**Re Proposed Draft Plan of Subdivision, Draft Plan of Condominium, Zoning By-law Amendment and Site Plan Application  
Villa Lago Residence Inc (c/o Treasure Hill Homes)  
9023 5 Sideroad, Part Lot 5, Concession 7 (ALB)  
File Numbers: 21T-16003C; CDM-16002C, RZ 16-06, SPA 16-042**

**Re: Architectural Control/ Urban Design Peer Review  
Proposed Site Plan Approval Application  
Villalago Residences Inc.  
9023 5<sup>th</sup> Sideroad (Part of Lot 5 and Part of the Road Allowance between West  
Halves of Lots 5 and 6, Concession 7 and Blocks 118, 152 – 154, 165, 167, 178,  
181 and 182), Registered Plan 43M-1251 (Albion)  
Town File No: 21T-16003C, CDM-16002C, RZ-16-06, SPA 16-042  
Our Ref No.: W-2026**

Figure 3.1 - Conceptual Landscape Plan.

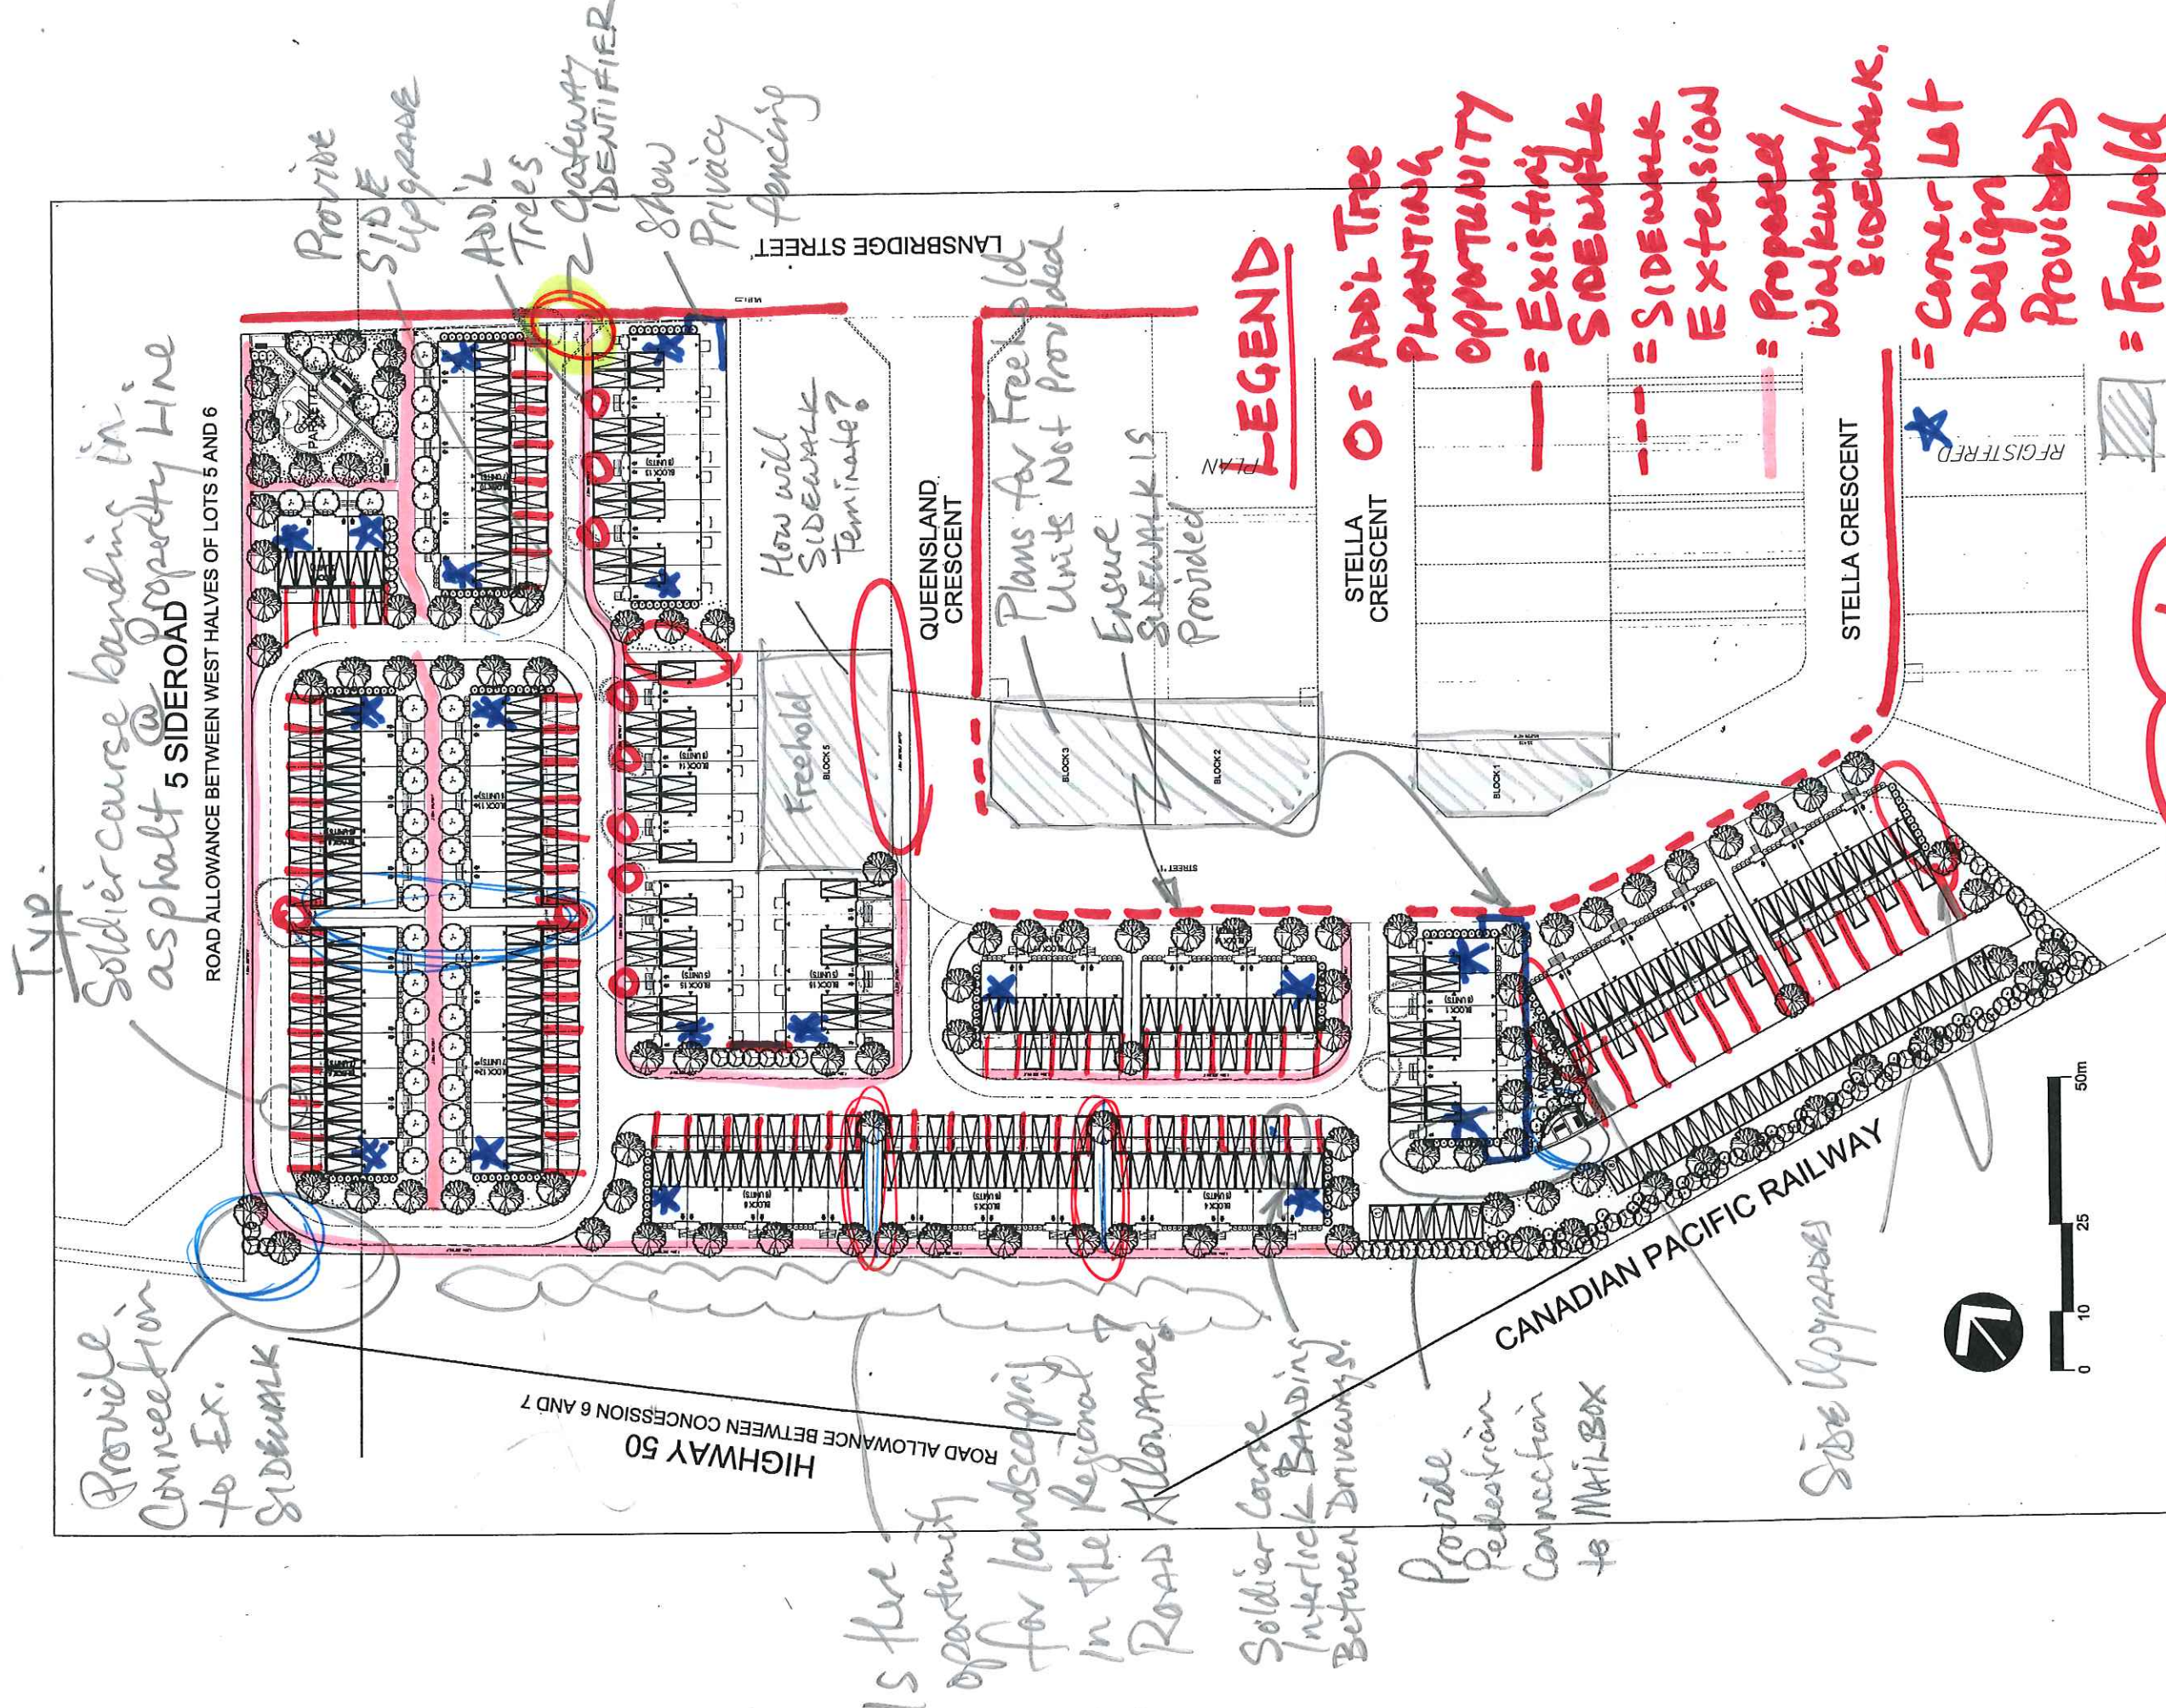
- Please define what the small dark blue circles are in the legend on page 6.
  - Please provide information on the freehold lots addressing the streetscape treatment and add the streetscape treatment to figure 3.1.

- 3) On Figure 2.3 it is unclear whether the existing sidewalk on Stella Cres. will be extended. This sidewalk should continue along the west side of the new portion of Stella Cres. to ensure that proposed dual frontage townhouses on Blocks 2, 3, 17 & 18 will have direct access from their front door to a sidewalk.

- 4) Although noted in the text in Section 2.2, pedestrian crossing locations should be shown on the plan.
- 5) A detailed Landscape Plan should be provided, in the meantime we have reviewed the conceptual landscape plan (Figure 3.1) and offer the following comments:

A1.1

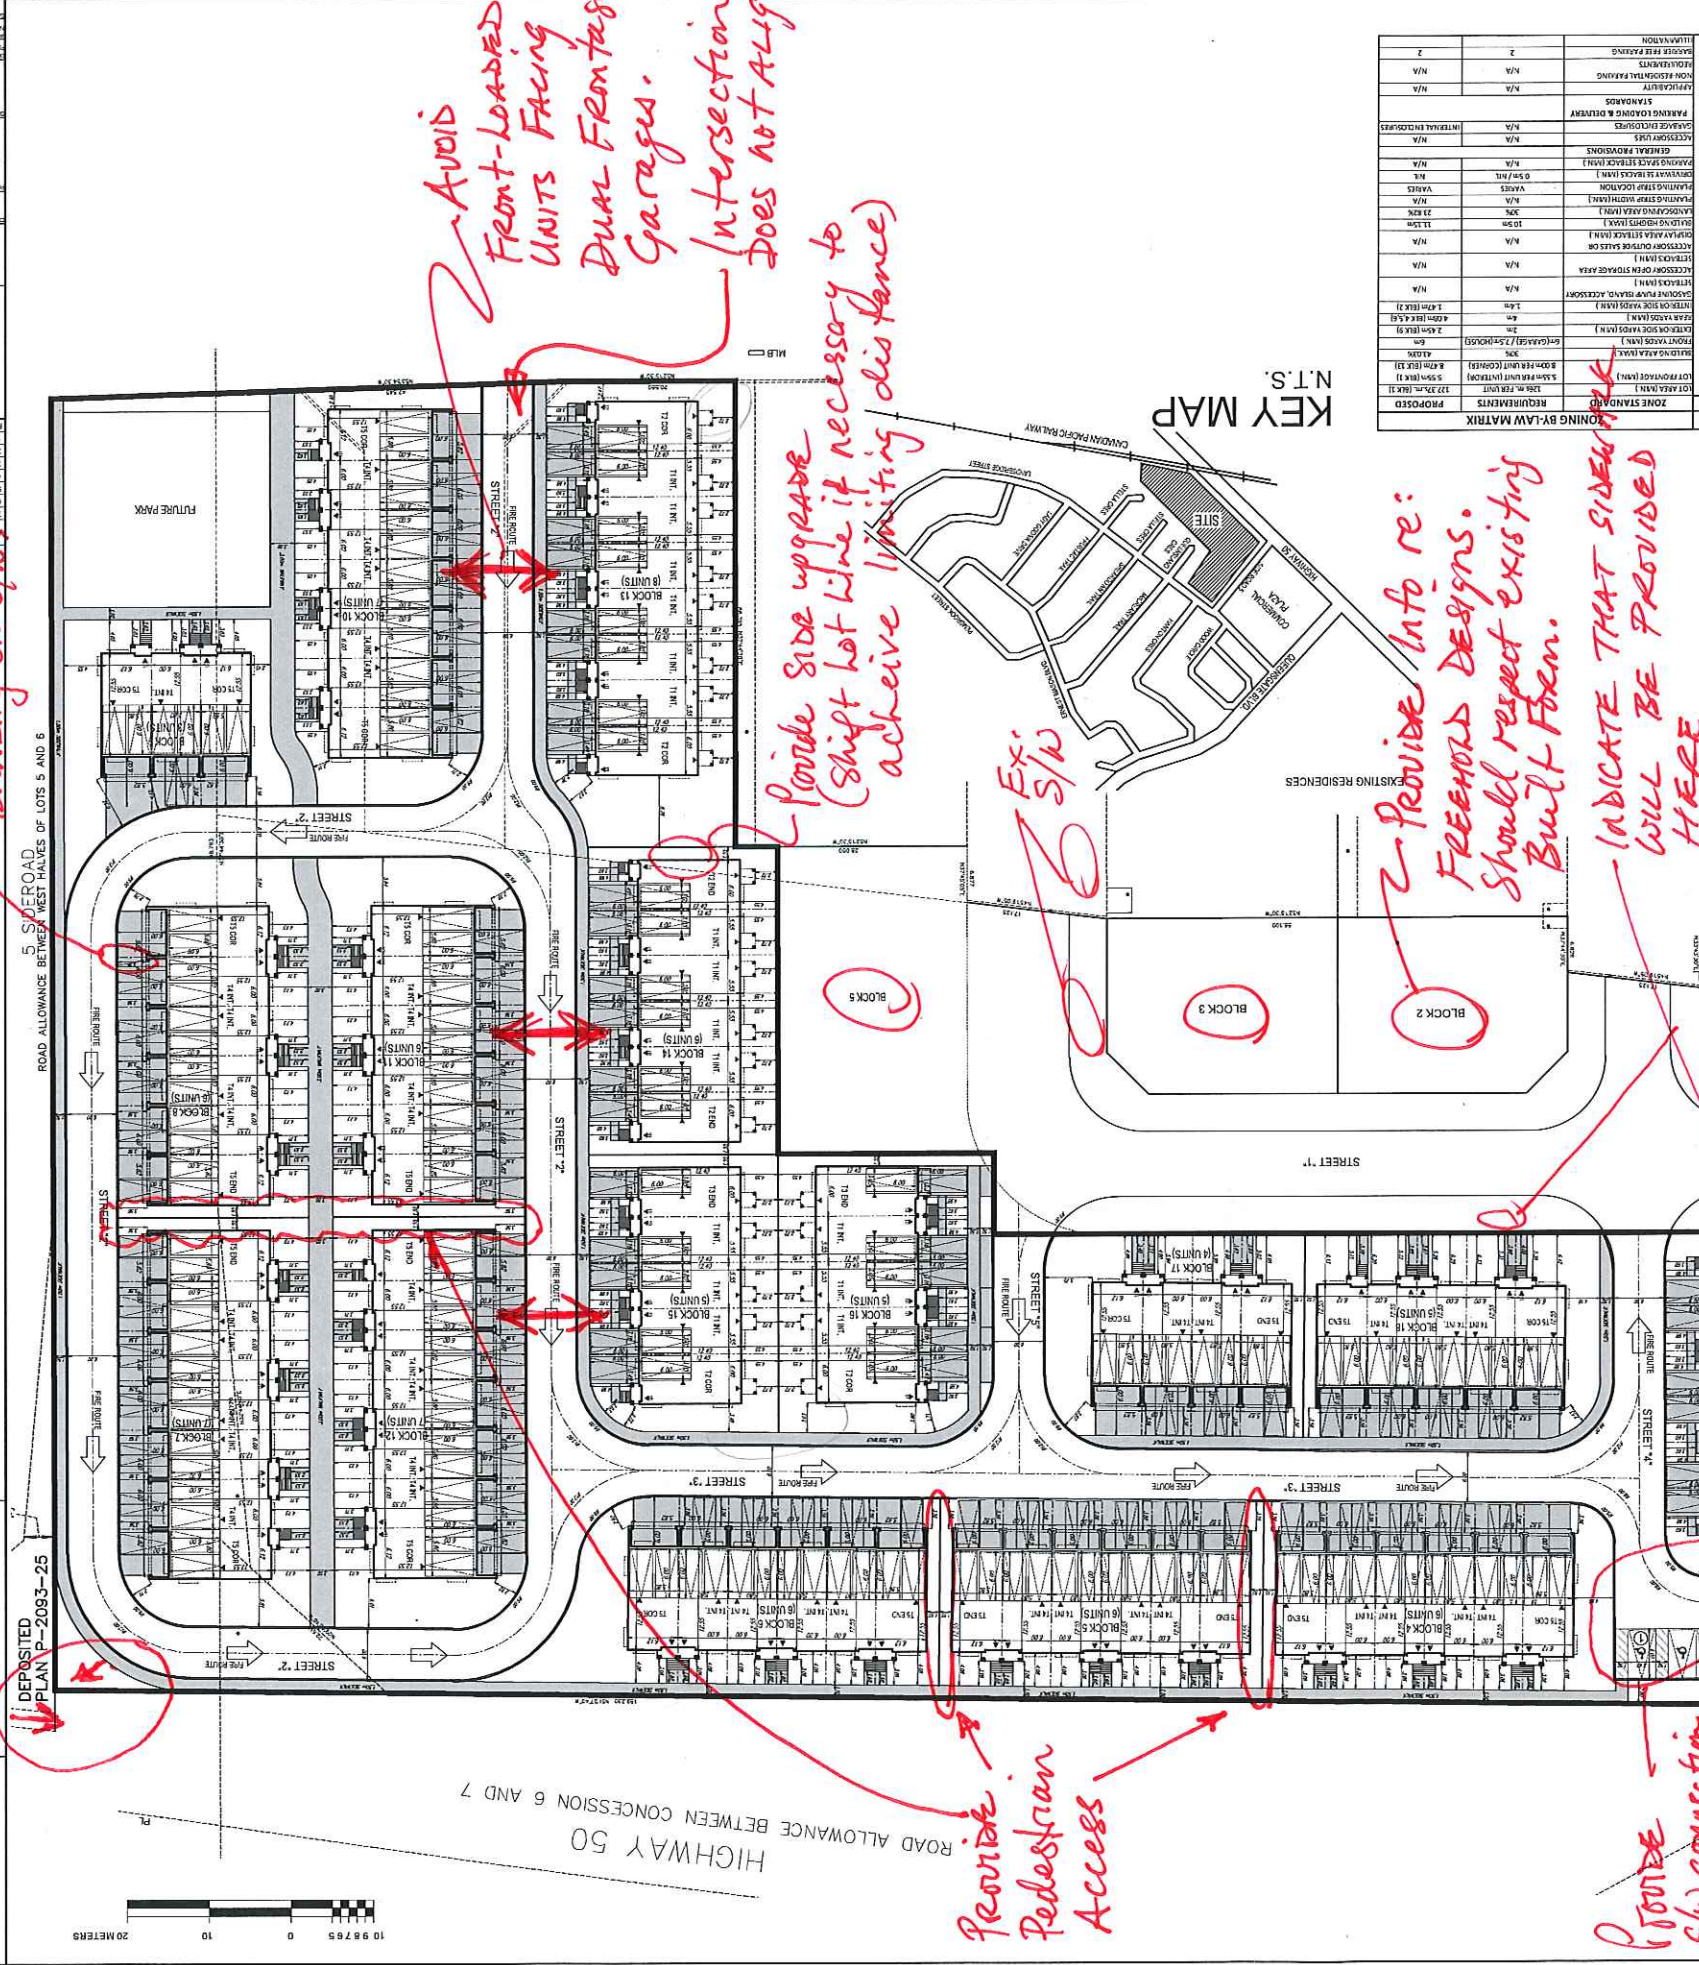
28. The applicant should revise the site plan to indicate the building setback from the railroad right of way.  
*TOC – Development, Zoning*
29. Adequate Fire Department turn around has not been provided at the end of Street “4”/Block 3. *TOC, Fire & Emergency Services & Building*

- 5) Visitor parking is concentrated in the southern portion of the plan adjacent to the rail line berm / noise barrier and opposite a bank of garages (Blocks 2 & 3). This creates two concerns: 1) visitor parking is not equally / conveniently distributed throughout the site; 2) the location is isolated and creates CPTED safety concerns.

- 6) Proposed fencing treatments (including noise fencing, decorative fencing and privacy fencing) should be identified (location and type) on a plan.

NORTH ELEVATION  
(LEFT SIDE)

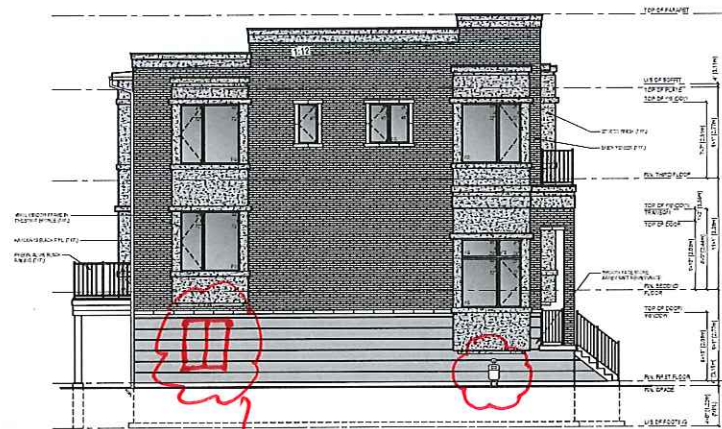
ADD WINDOW FOR CORNER UNITS:

SOUTH ELEVATION  
(RIGHT SIDE)

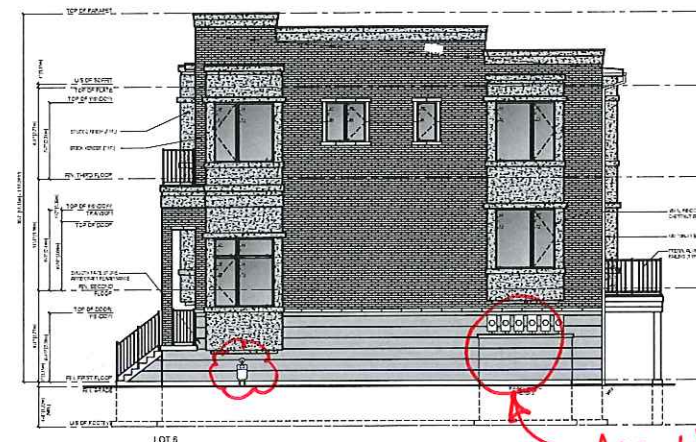
ADD WINDOW for Corner Units (where gauged meters are located on interior side)

WEST ELEVATION  
(FRONT)

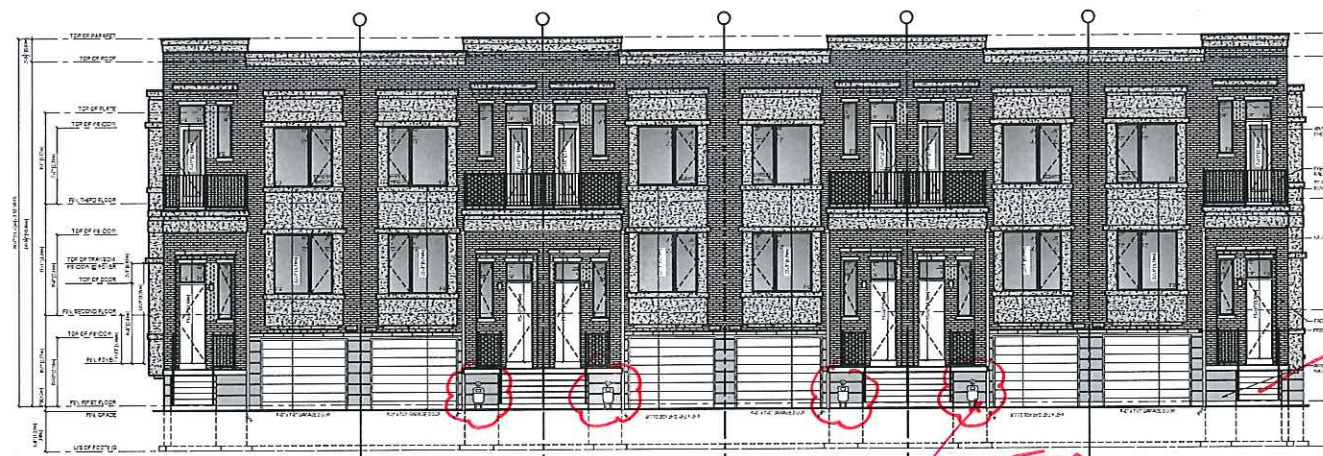
PROVIDE LANDSCAPE SCREENING (TYP.) FOR GAS METERS.

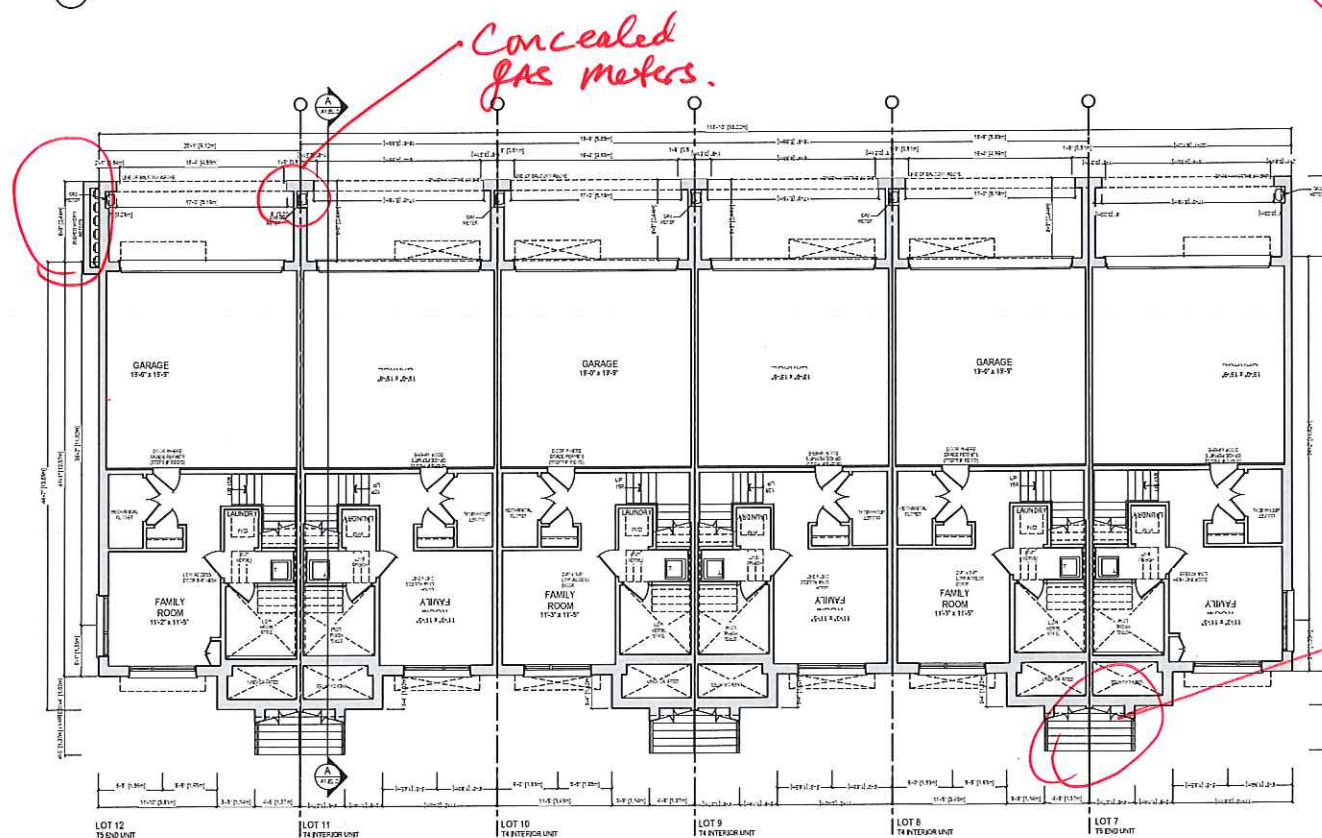
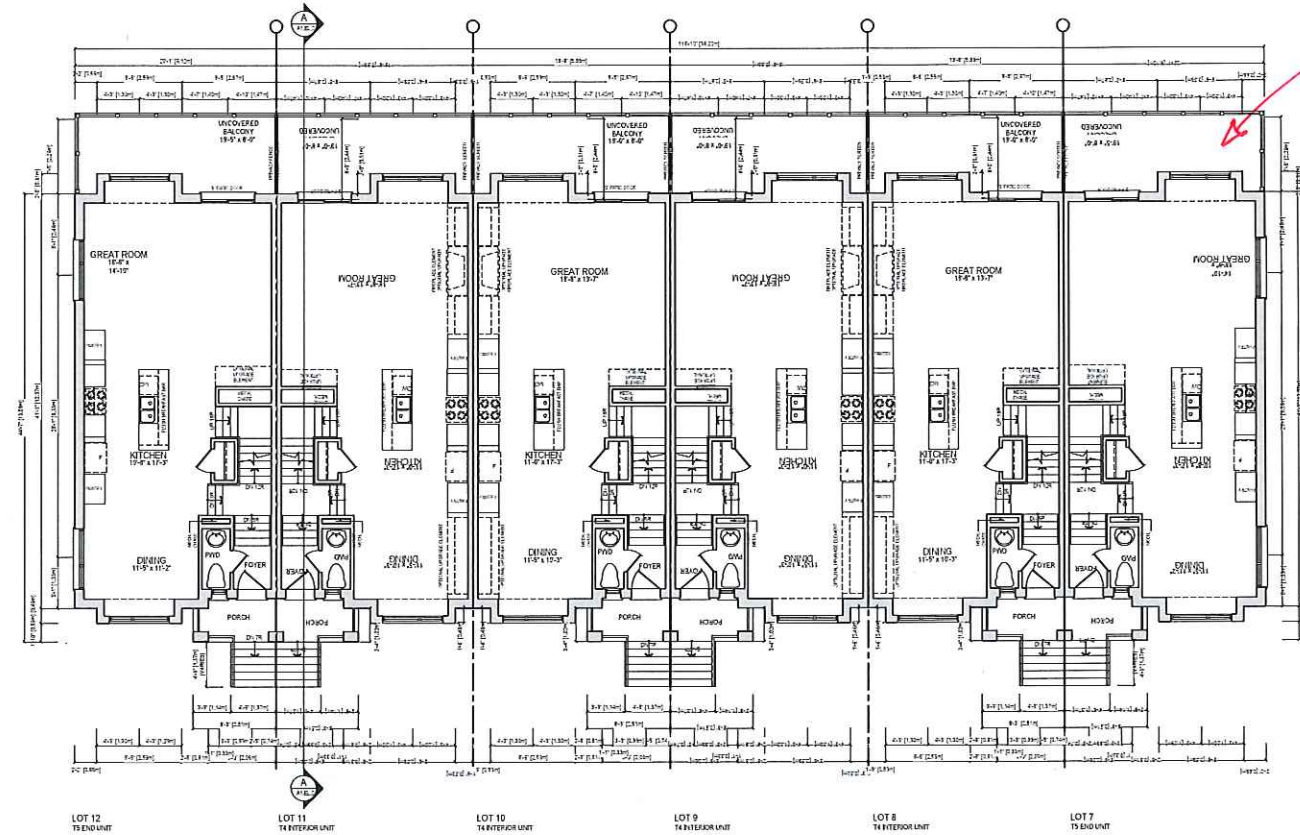
ganged hydro meters

Typ.  
LOCATE AIR CONDITIONING  
UNITS ON REAR DECK AWAY  
FROM PUBLIC VIEWS. (TYP.)
